Los Medanos College
Campus Key Plan

CCCCD - Los Medanos

Route #1 - Los Medanos Campus

Path of Travel
Route #5

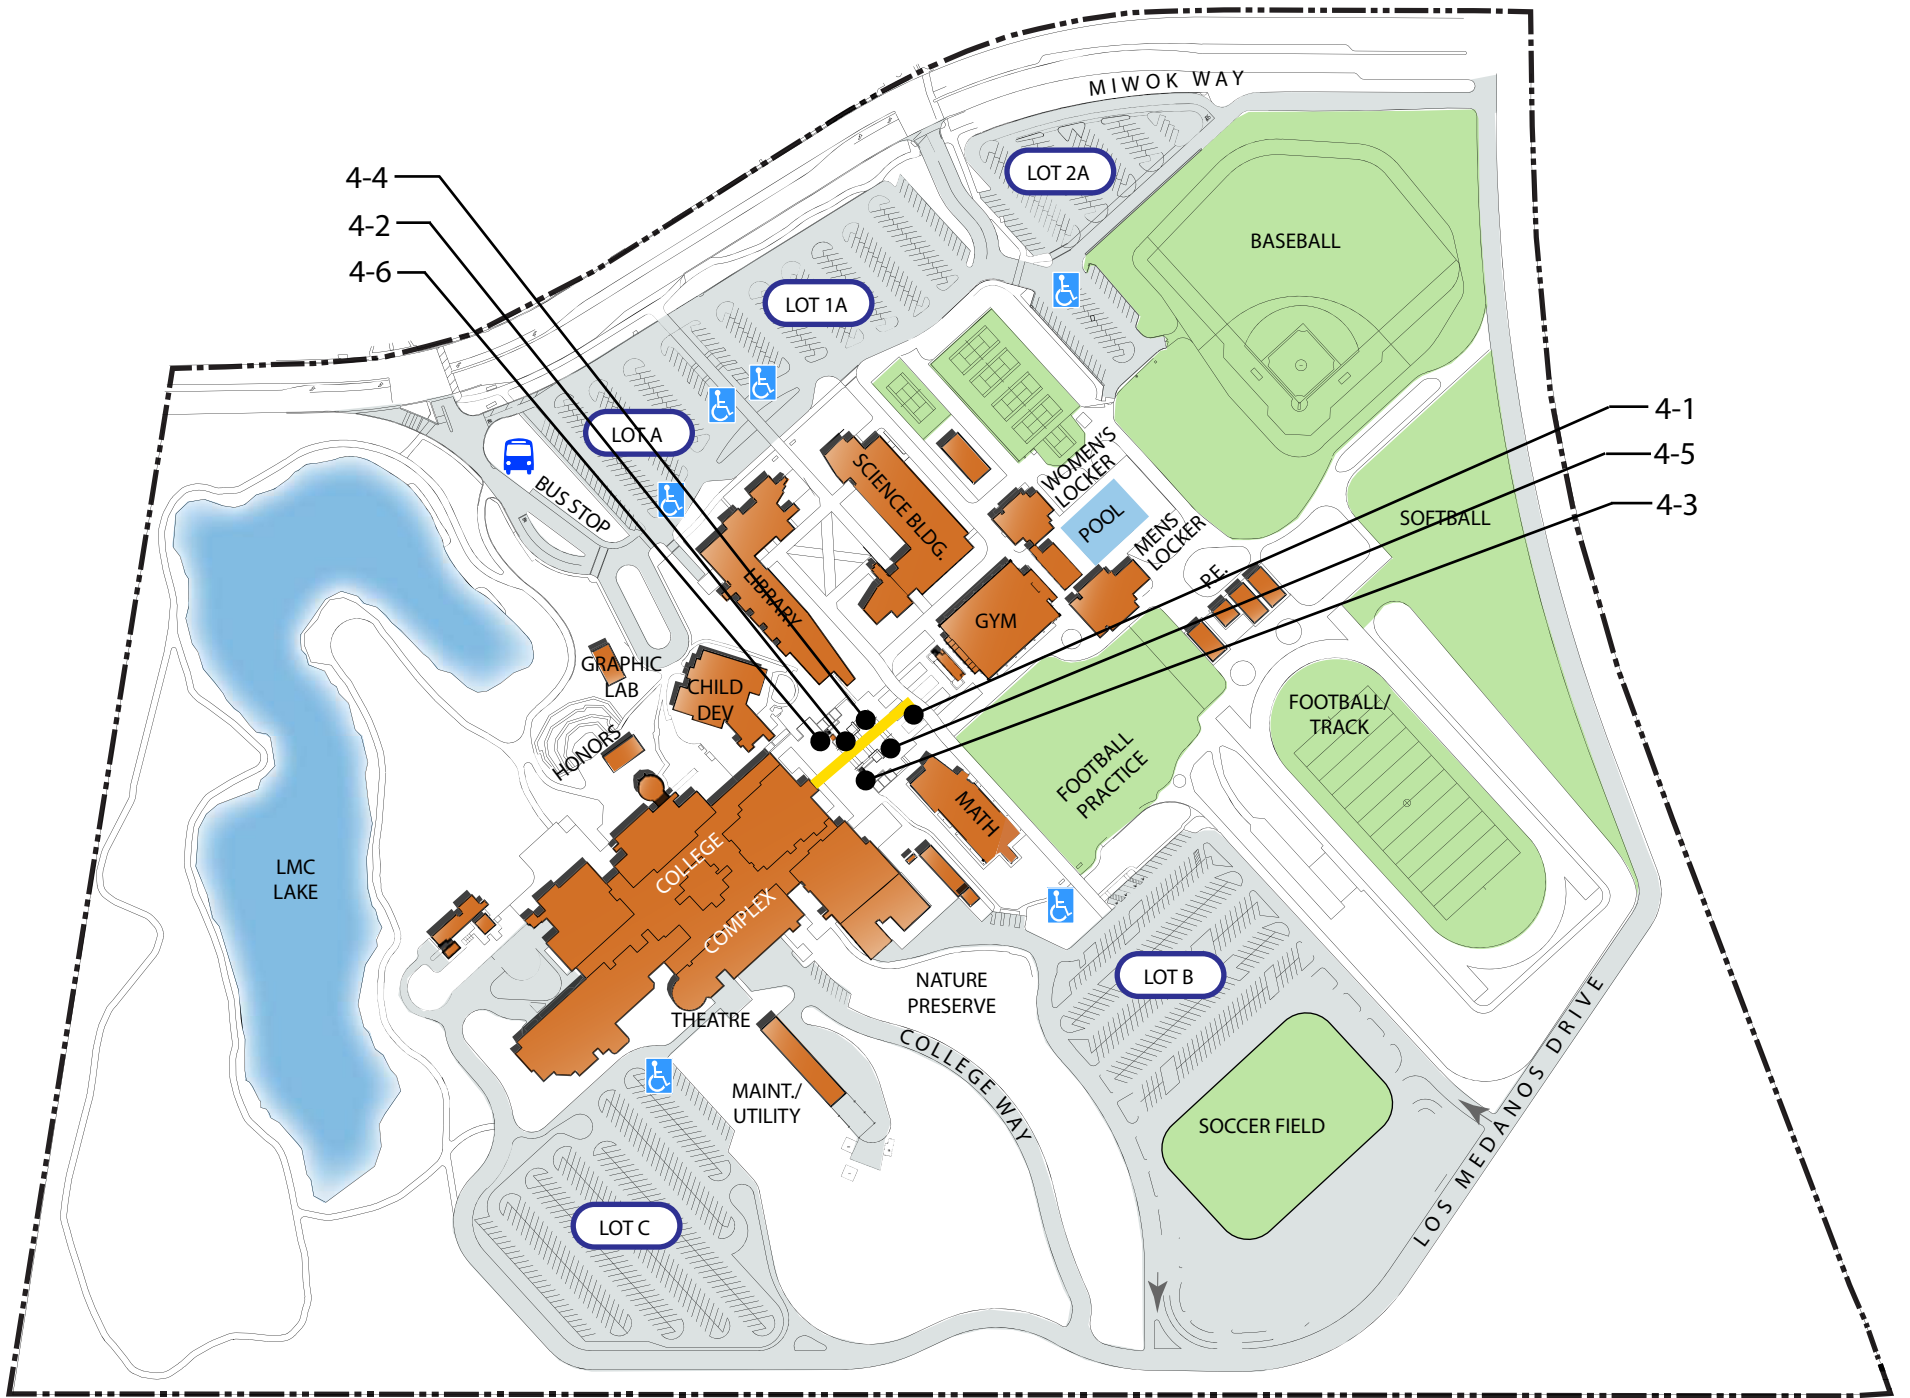
Exterior	
4 - 1	Walk Feature Priority: 1
Provide a firm, stable and slip resistant surface \$2,000	
Notes: Surfaces are slippery when wet from sprinklers, which is most likely the case for surrounding area with similar surface.	
State: 1124B.1, 1133B.7.1	
Federal: 4.5.1	
Action Priority: S	
4 - 2	Walk Feature Priority: 1
Replace or reorient grate \$500	
Notes: Gratings have openings 1" (1/2" max) wide in one direction. Gratings are not positioned so the longest dimension of openings is perpendicular to the predominant path of travel.	
State: 1124B.4, 1133B.7.2	
Federal: 4.5.4	
Action Priority: S	
4 - 3	Walk Feature Priority: 1
Replace or reorient grate \$500	
Notes: Gratings have openings 1" (1/2" max) wide in one direction. Gratings are not positioned so the longest dimension of openings is perpendicular to the predominant path of travel.	
State: 1124B.4, 1133B.7.2	
Federal: 4.5.4	
Action Priority: S	
4 - 4	Walk Feature Priority: 1

Replace or reorient grate \$500	
Notes: Gratings are not positioned so the longest dimension of openings is perpendicular to the predominant path of travel.	
State: 1124B.4, 1133B.7.2	
Federal: 4.5.4	
Action Priority: S	
4 - 5	Walk Feature Priority: 1
Replace or reorient grate \$500	
Notes: Gratings are not positioned so the longest dimension of openings is perpendicular to the predominant path of travel.	
State: 1124B.4, 1133B.7.2	
Federal: 4.5.4	
Action Priority: S

Exterior	
4 - 6	Walk
	Feature Priority: 1
Replace or reorient grate	\$500
Notes: Gratings are not positioned so the longest dimension of openings is perpendicular to the predominant path of travel.	
State: 1124B.4, 1133B.7.2	
Federal: 4.5.4	
Action Priority: S

Path of Travel
Route #8

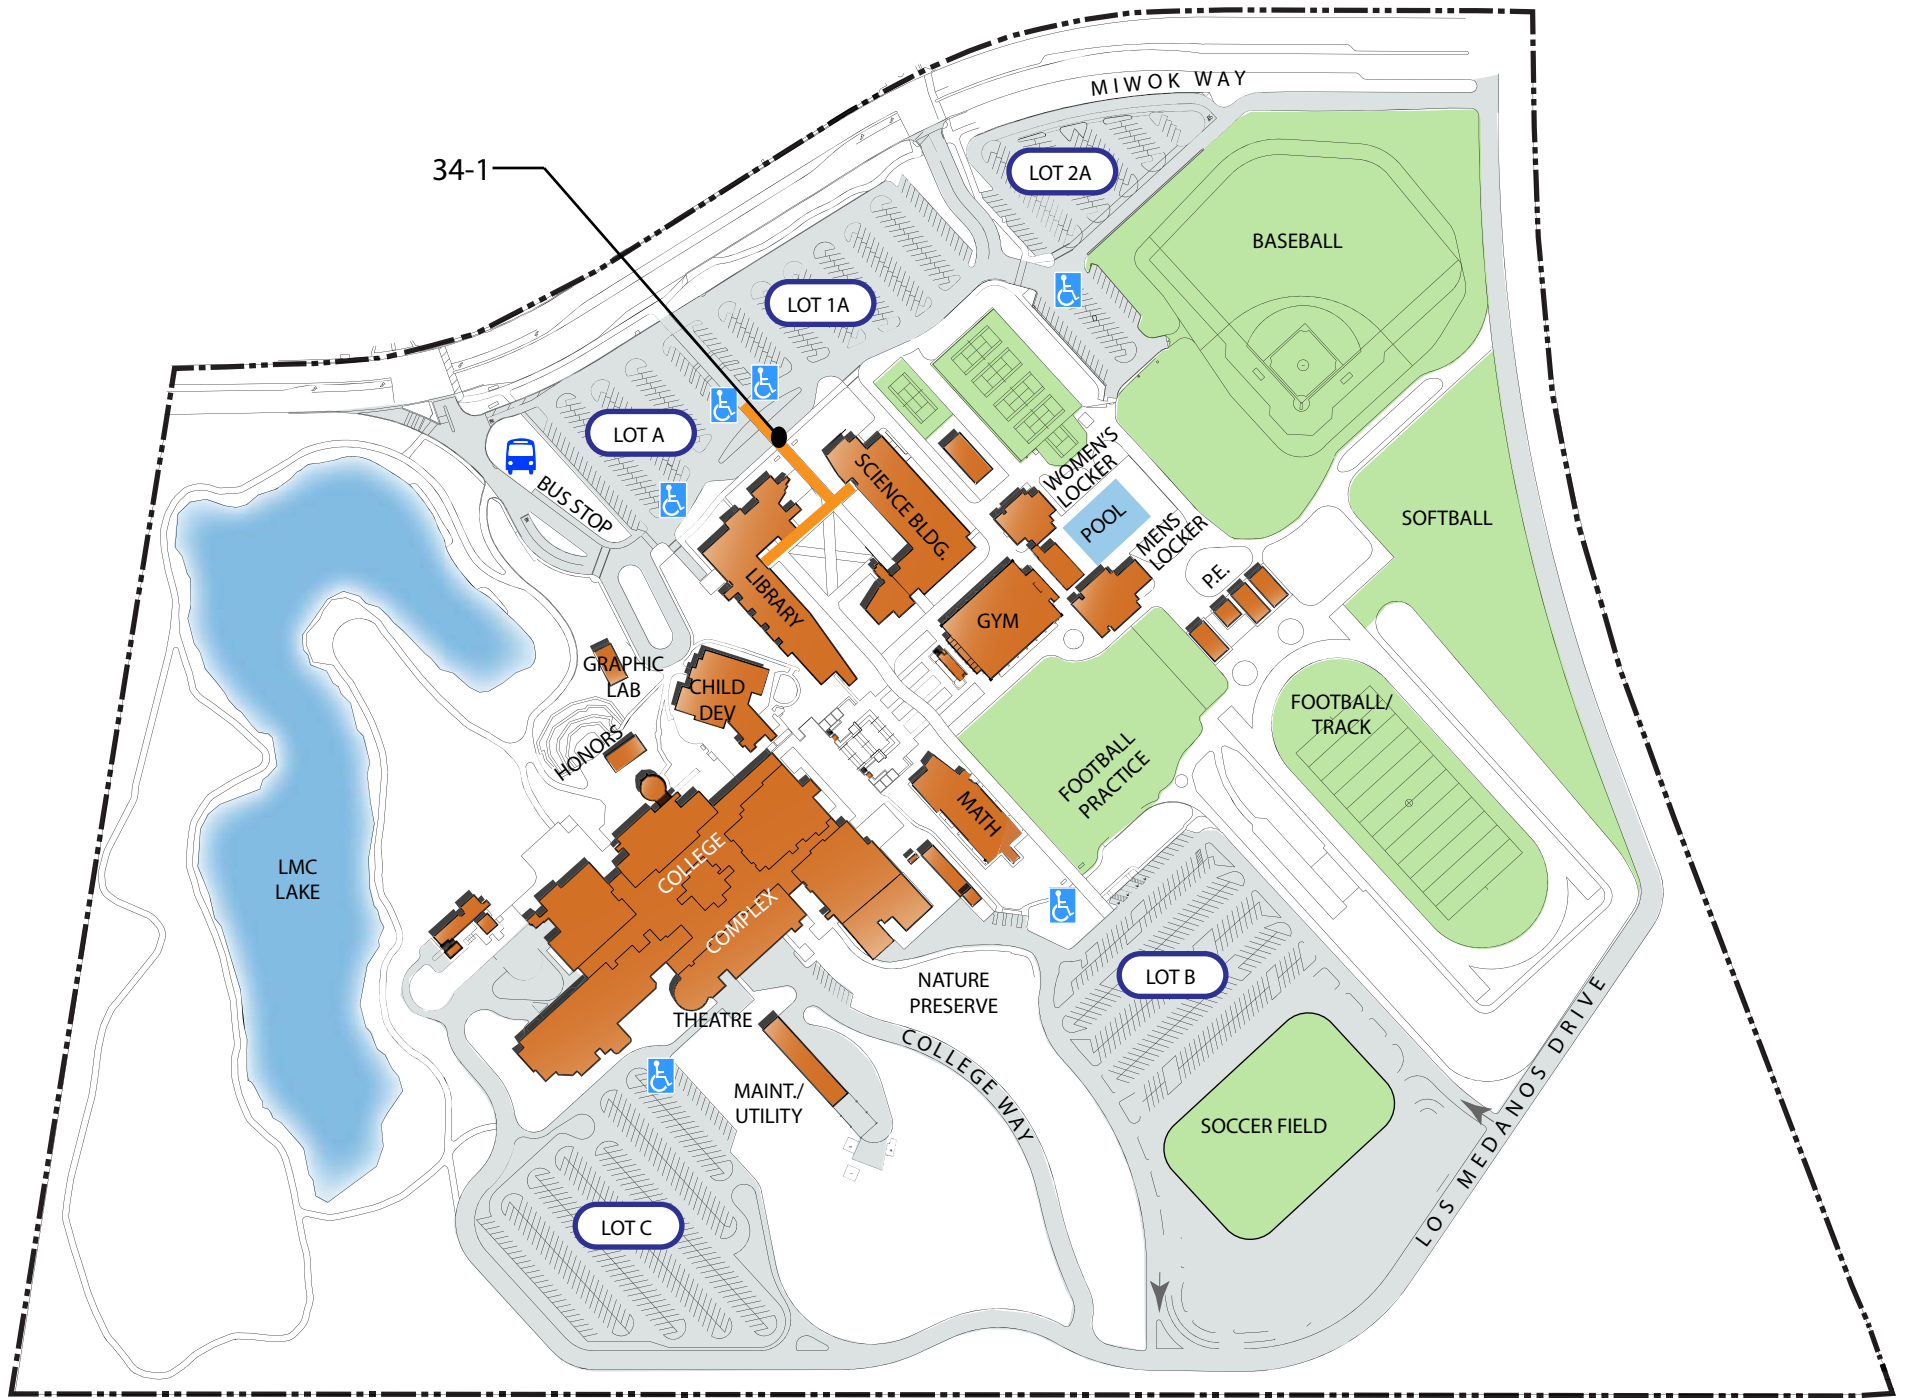
Exterior	
34 - 1	Fixed Bench Feature Priority: 4
Provide accessible fixed bench	\$6,000
Notes: All 4 benches along the path of travel do not provide a full length back support or at least one armrest. The front edge seat height is 19-1/2"(17"-19" max) for all 4 benches.

Path of Travel
Route #9

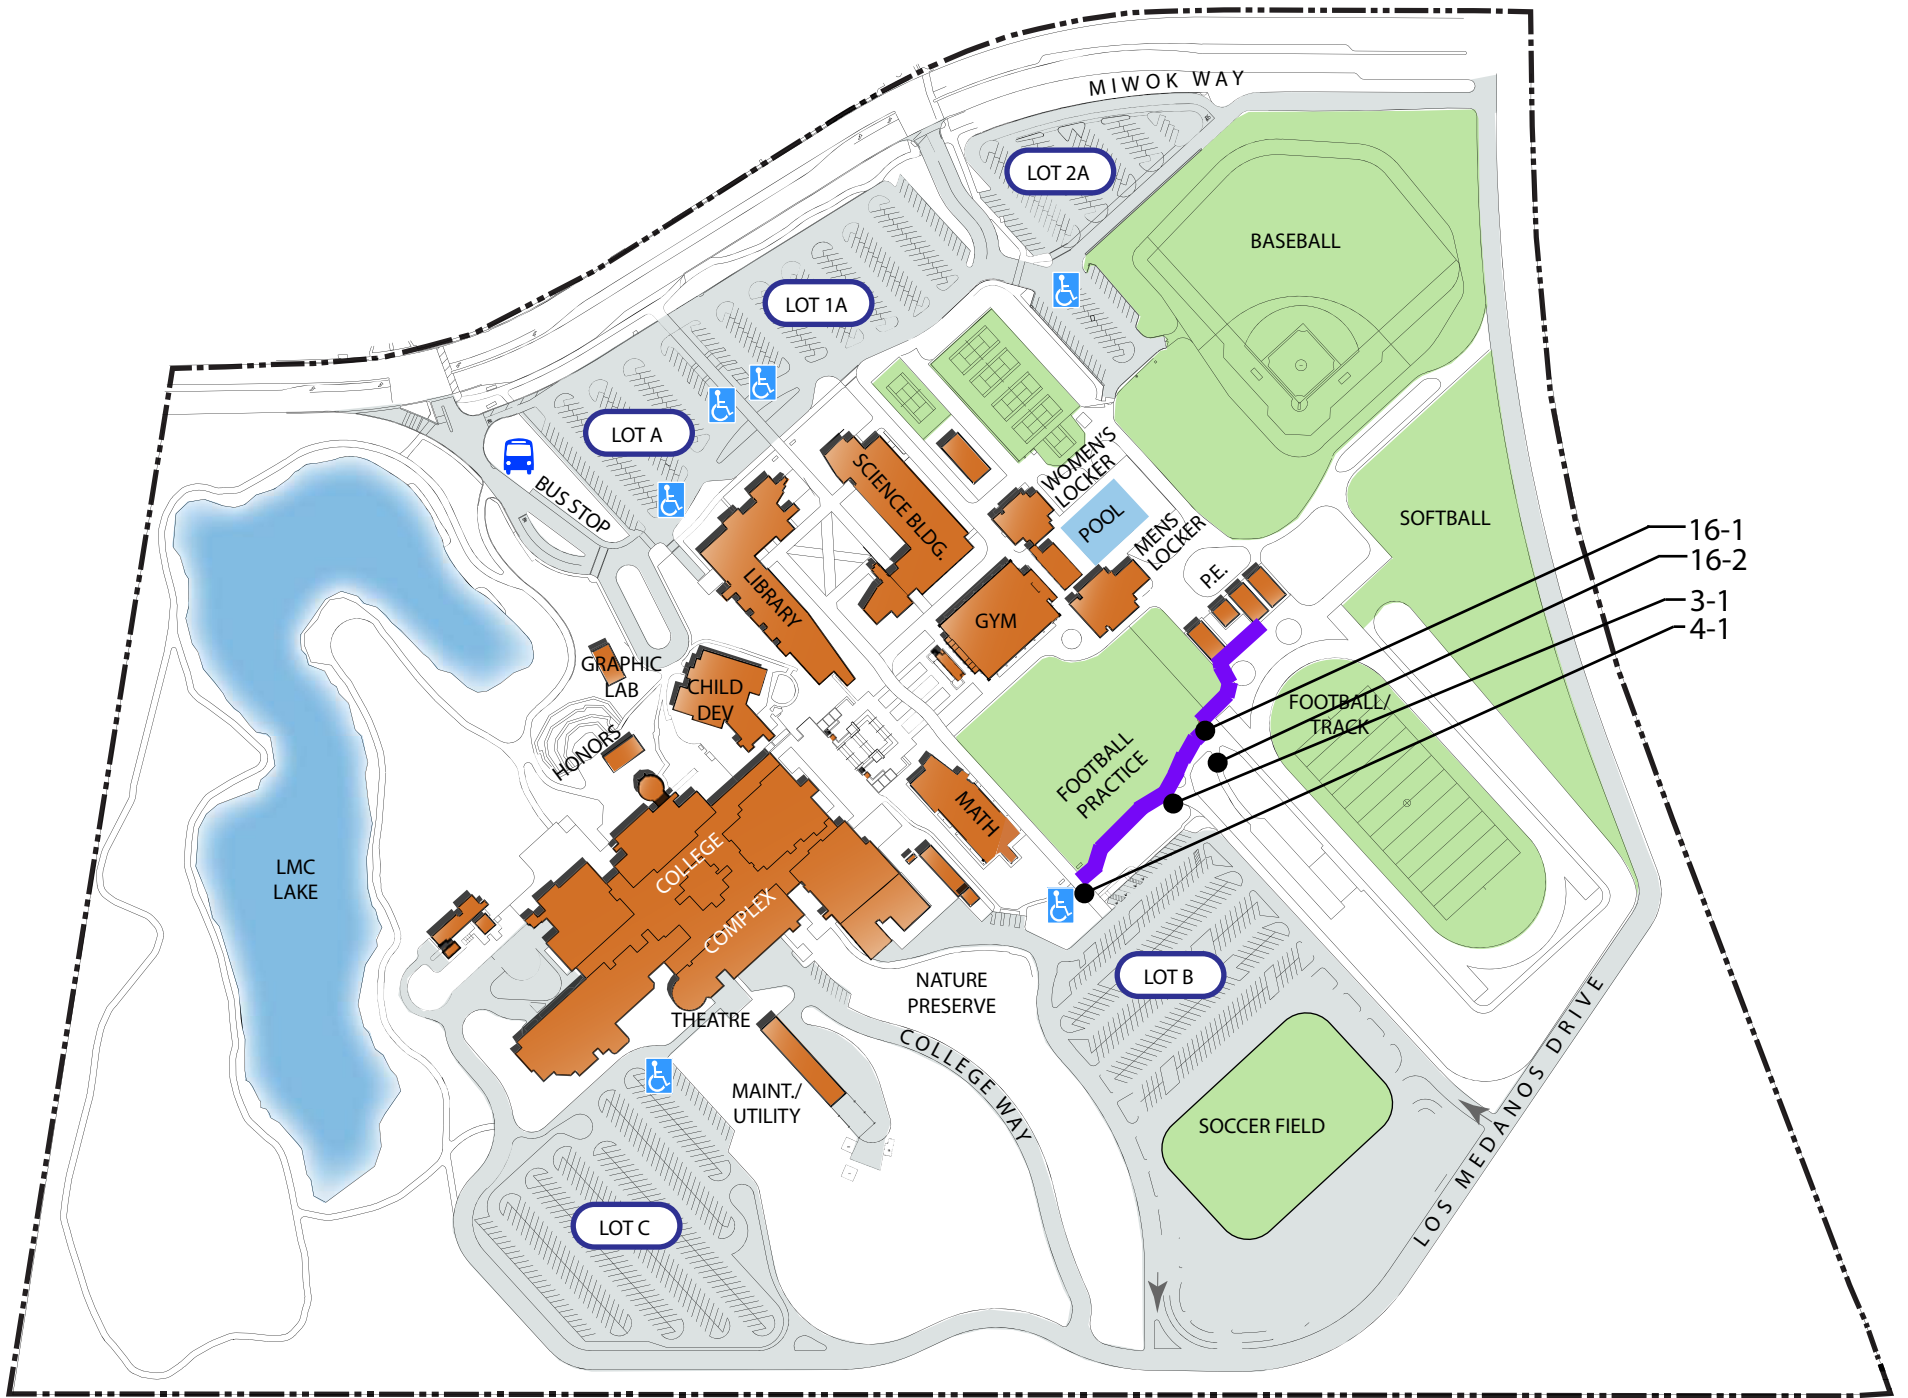
Exterior	
3 - 1	Curb Ramp Feature Priority: 1
Provide surface texturing	\$500
Notes: A 12" wide grooved border is not provided on the sidewalk surface.	
State: 1127B.5 #6	
Federal: 4.7.4	
Action Priority: <none>	
Provide or relocate crossing or curb markings	\$500
Notes: Ramp is not protected to prevent obstruction by parked vehicles.	
State: 1129B.5 #1	
Federal: 4.7.6	
Action Priority: <none>	
4 - 1	Walk Feature Priority: 1
Regrade surface	\$1,000
Notes: Running slope is 5.9%(5% max). And cross slope is 2.5%(2% max).	
State: 1133B.7.1.3	
Federal: 4.3.7	
Action Priority: <none>	
16 - 1	Transaction Counter Feature Priority: 3
Provide an accessible counter	\$1,000
Notes: Transaction counter height is 49"(36" max) above the floor. Counter is 20-7/8" (35" min) long.	
State: 1110B.1.3, 1122B.5	
Federal: 4.32.4, 7.3 #2	
Action Priority: <none>	
16 - 2	Transaction Counter Feature Priority: 3
Provide an accessible counter	\$1,000

Notes: Transaction counter height is 49"(36" max) above the floor. Counter is 20-7/8" (35" min) long.	
State: 1110B.1.3, 1122B.5	
Federal: 4.32.4, 7.3 #2	
Action Priority: <none>

College Complex
Business Labs - 8

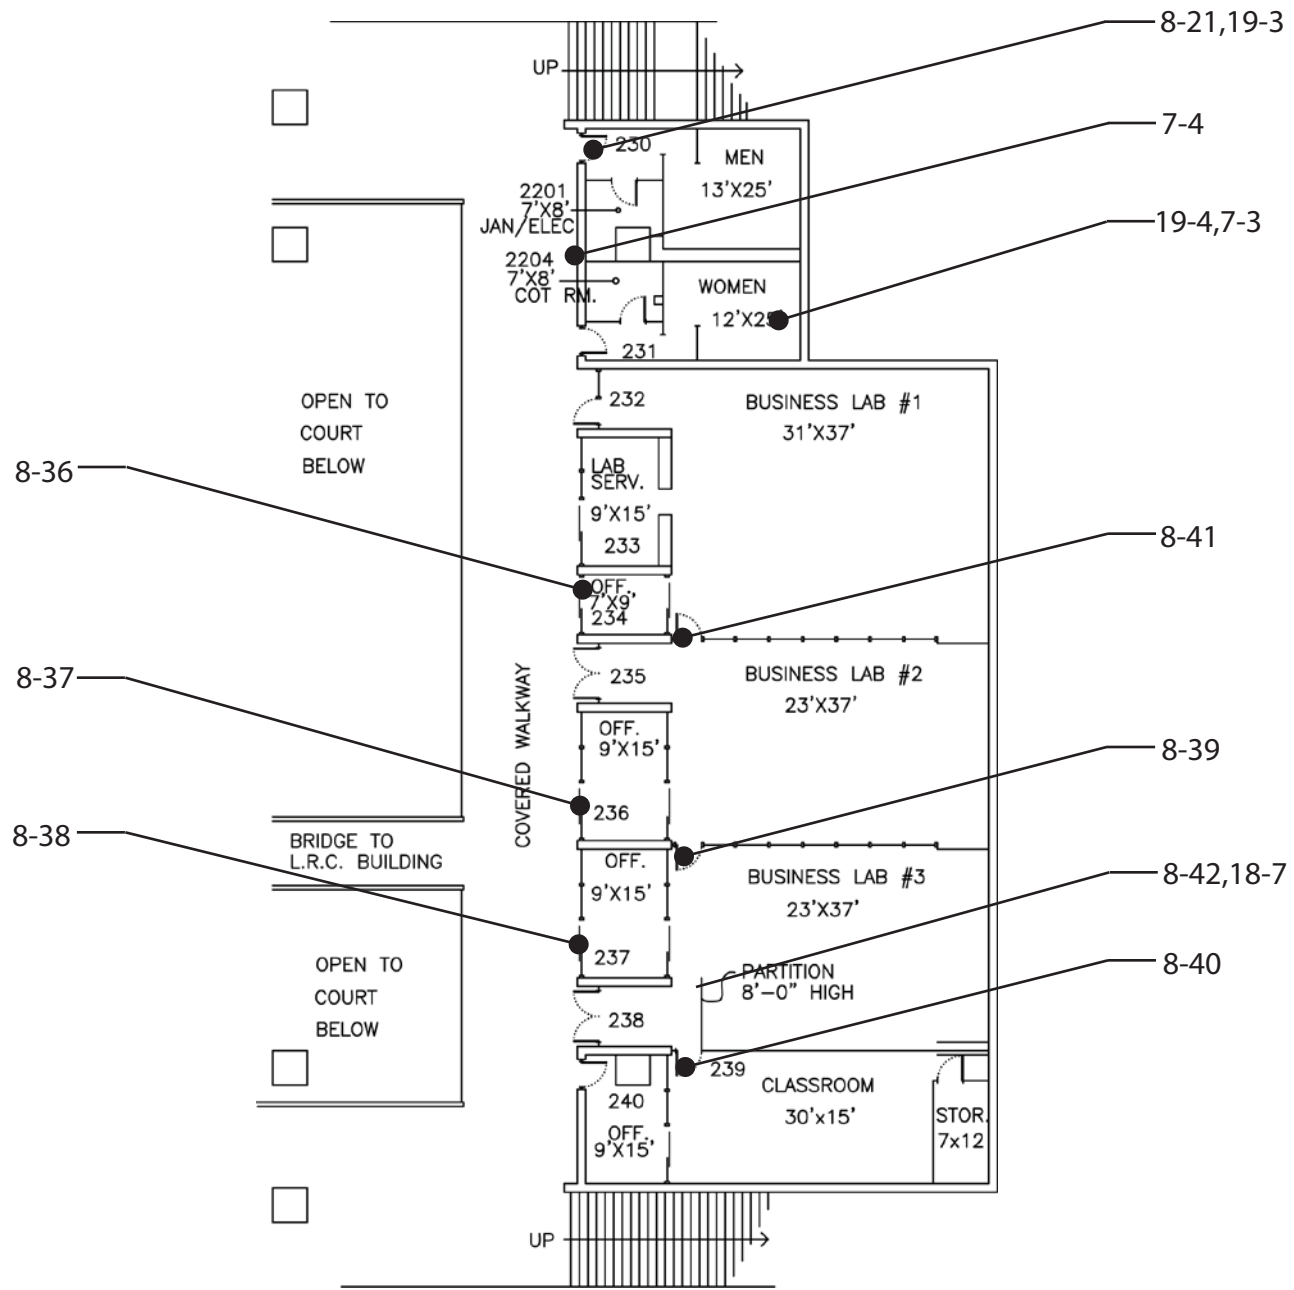
Floor 2	
7 - 3	Hazard Feature Priority: 1
Remove overhanging or protruding objects	\$100
Notes: Towel dispenser protrudes 10" (4" max) and is 36" (not between 27" to 80") above the finished floor.	
State: 1133B.8.6.1	
Federal: 4.4.1	
Action Priority: M	
7 - 4	Hazard Feature Priority: 1
Remove overhanging or protruding objects	\$100
Notes: Drinking fountain protrudes 19" (4" max) and is 29" (not between 27" to 80") above the finished floor.	
State: 1133B.8.6.1	
Federal: 4.4.1	
Action Priority: M	
8 - 21	Door/Gate Feature Priority: 2
Increase or provide maneuvering or clear floor area	\$1,000
Notes: Slope on the push-side is 4.4% (2% max).	
State: 1133B.2.4.2	
Federal: 4.13.6	
Action Priority: S	
Provide additional strike edge clearance	\$1,000
Notes: Strike-edge clearance on push-side is 6" (18" min).	
State: 1133B.2.4.3	
Federal: 4.13.6	
Action Priority: S	
8 - 36	Door/Gate Feature Priority: 2
Replace or modify door threshold	\$200

Notes: Threshold is 1-1/2" (1/2" max) high.	
State: 1133B.2.4.1	
Federal: 4.13.8	
Action Priority: S	
Provide or modify door kickplate	\$250
Notes: Kickplate is 3" (10" min) high.	
State: 1133B.2.6	
Federal: -	
Action Priority: S

Floor 2	
8 - 37	Door/Gate Feature Priority: 2
Replace or modify door threshold	\$200
Notes: Threshold is 1-1/2" (1/2" max) high.	
State: 1133B.2.4.1	
Federal: 4.13.8	
Action Priority: S	
Provide or modify door kickplate	\$250
Notes: Kickplate is 3" (10" min) high.	
State: 1133B.2.6	
Federal: -	
Action Priority: S	
8 - 38	Door/Gate Feature Priority: 2
Replace or modify door threshold	\$200
Notes: Threshold is 1-1/2" (1/2" max) high.	
State: 1133B.2.4.1	
Federal: 4.13.8	
Action Priority: S	
Provide or modify door kickplate	\$250
Notes: Kickplate is 3" (10" min) high.	
State: 1133B.2.6	
Federal: -	
Action Priority: S	
8 - 39	Door/Gate Feature Priority: 2
Provide or modify door kickplate	\$250
Notes: Kickplate is 5" (10" min) high.	
State: 1133B.2.6	
Federal: -	
Action Priority: S

Floor 2	
8 - 40	Door/Gate Feature Priority: 3
Provide or modify door kickplate	\$250
Notes: Kickplate is 5" (10" min) high.	
State: 1133B.2.6	
Federal: -	
Action Priority: S	
8 - 41	Door/Gate Feature Priority: 3
Provide or modify door kickplate	\$250
Notes: Kickplate is 5" (10" min) high.	
State: 1133B.2.6	
Federal: -	
Action Priority: S	
8 - 42	Door/Gate Feature Priority: 3
Provide additional strike edge clearance	\$1,000
Notes: Strike-edge clearance on swing-side is 4" (18" min).	
State: 1133B.2.4.3	
Federal: 4.13.6	
Action Priority: S	
18 - 7	Room Feature Priority: 2
Remove overhanging or protruding objects	\$100
Notes: Fire extinguisher protrudes 6" (4" max) and is 42" (not between 27" to 80") above the finished floor.	
State: 1133B.8.6.1	
Federal: 4.4.1	
Action Priority: S
